UNITED STATES PATENT AND TRADEMARK OFFICE

APPLICATION NO.	FILING DATE	FIRST NAMED INVENTOR	ATTORNEY DOCKET NO.	CONFIRMATION NO.
09/785,456	02/20/2001	Hwan-Seong Yu	8733.394.00	5029

Office Action Summary

DETAILED ACTION

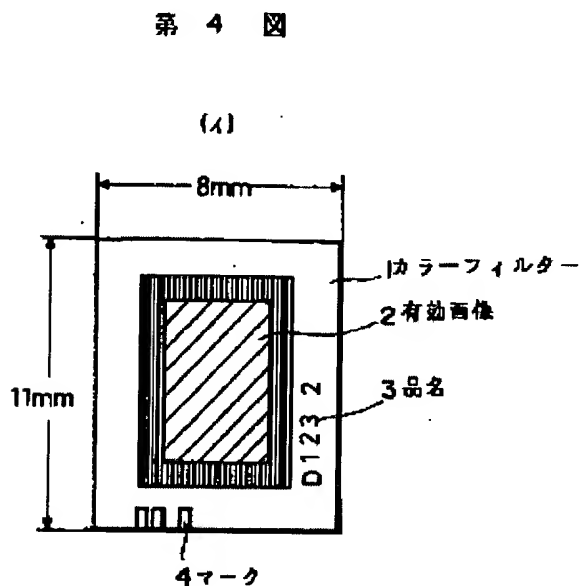
5. The AAPA described in the present application discloses in pages 3-4 and shows in Fig. 2, a color filter substrate for use in a liquid crystal display device comprising:

- a substrate;
- a black matrix (33) having a pattern on the substrate;
- red, green and blue color filters (35) corresponding to the pattern; and
- an alignment key (37) at the periphery of the substrate.

The AAPA differs from the claimed invention because it does not disclose the

identification mark being formed at the periphery of the substrate.
